Bardstown Road/Baxter Avenue Corridor Review Overlay District

Report of the Urban Design Administrator To the Overlay Committee

Case No: 15BROD1023
Classification: Non-Expedited

Property Address 1249 East Broadway, 656 Baxter Avenue, 652 Baxter Avenue

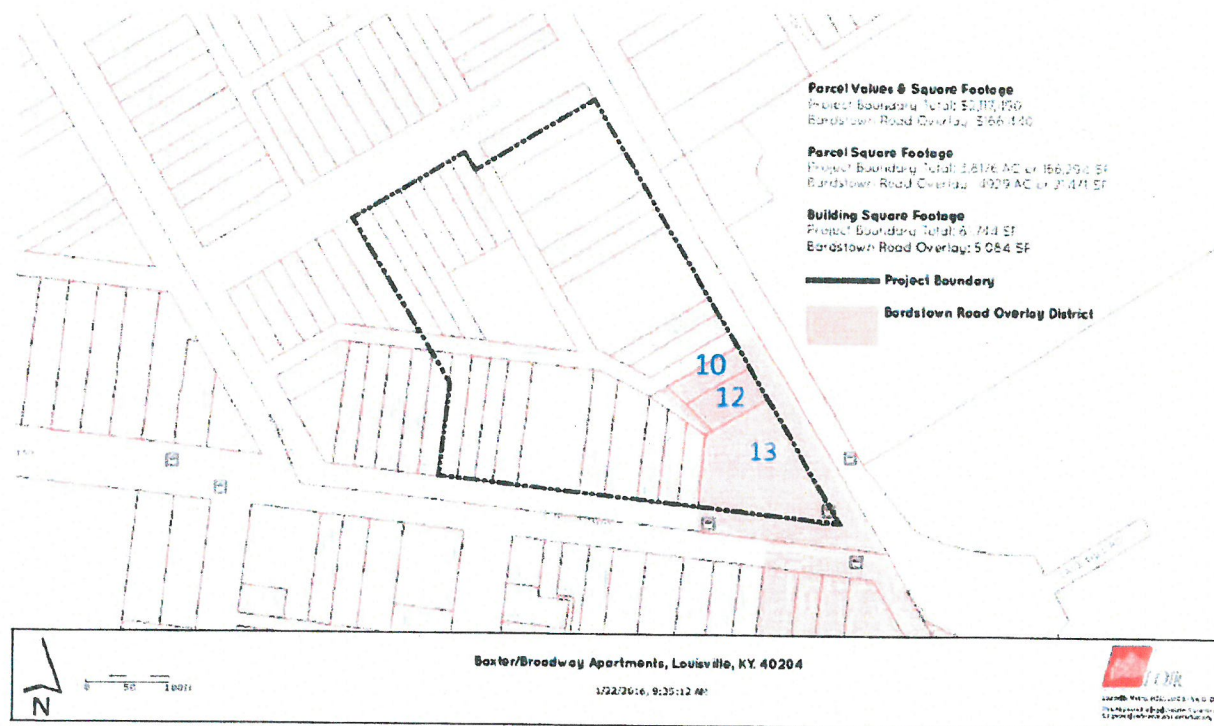
These three parcels are shown as #10 (652 Baxter Avenue), #12 (656 Baxter Avenue), and #13 (1249 E Broadway) on the submission map above. Parcel #10 is currently a vacant lot, and the structure on Parcel #12 will be razed for the development. Parcel #13 is currently surface parking. Approximately 15% to 20% (roughly 40,000sf) of the completed improvements will be constructed on these parcels, totaling an estimated \$6 million to \$8 million of the total budget.
